ZEN Design Consultants, Inc.

Re: Tarben Subdivision
16 Lot Residential Subdivision
Revere Road

Comments addressed from McGoey, Hauser & Edsall, dated 08/01/2016:

OUTLET STRUCTURE POND #2
N.T.S.

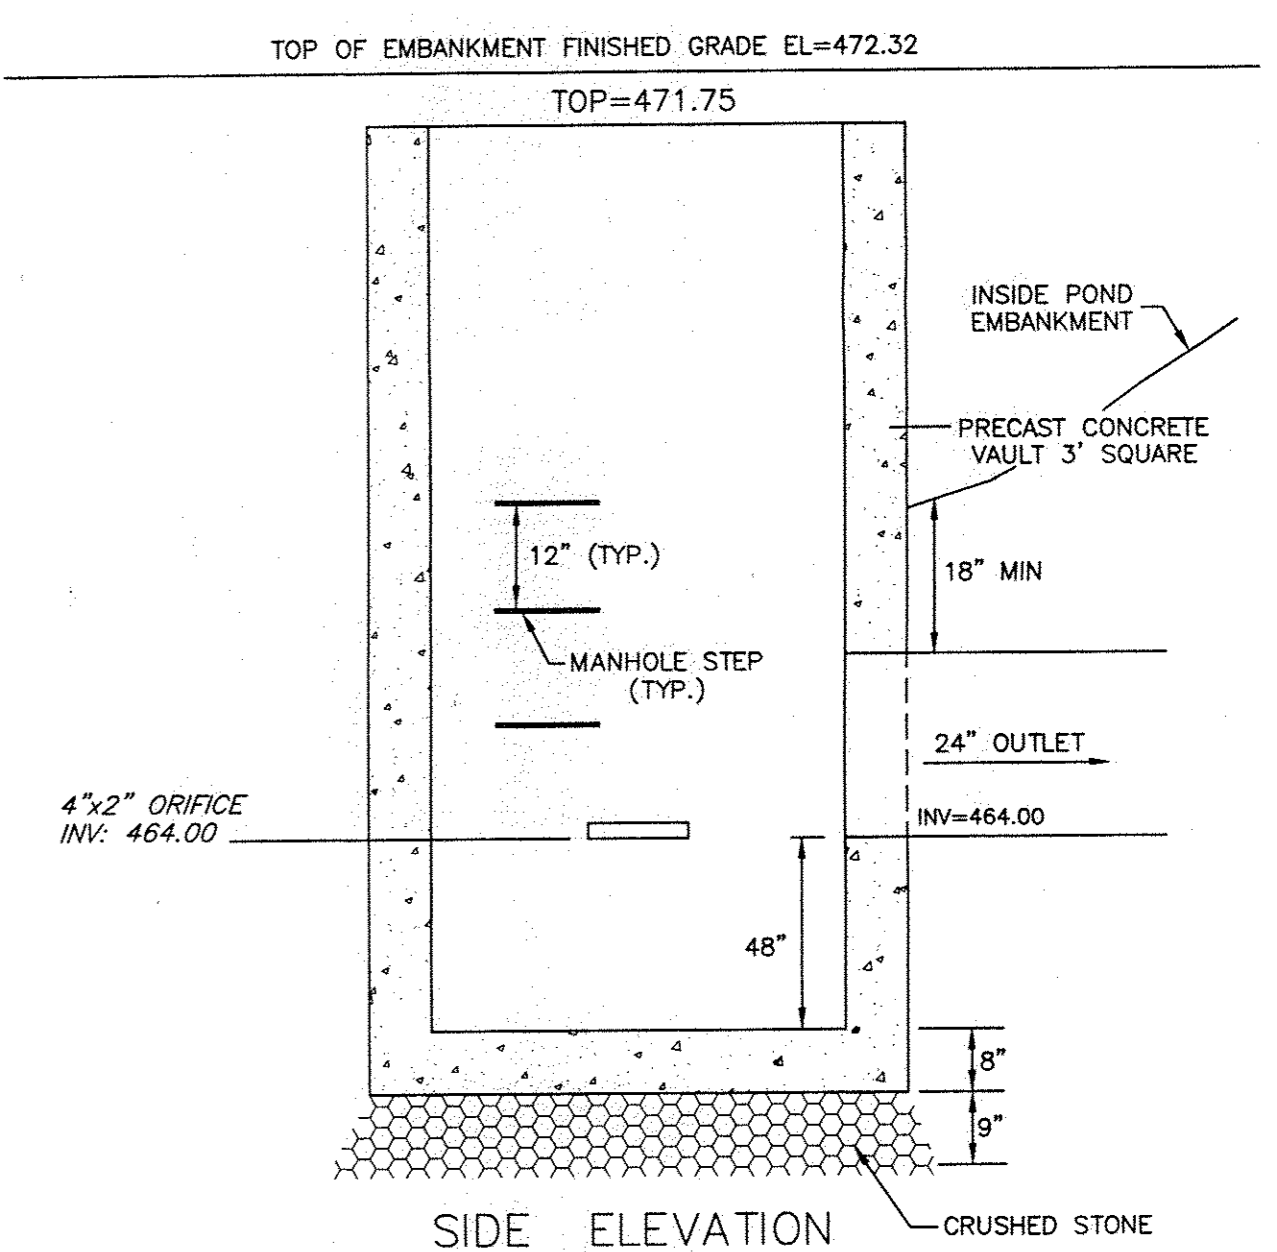
2. Stormwater Management pond has been revised. Revised Stormwater Management Report should be submitted modeling the revised pond.
The ponds location will remain in its original proposed location without change.
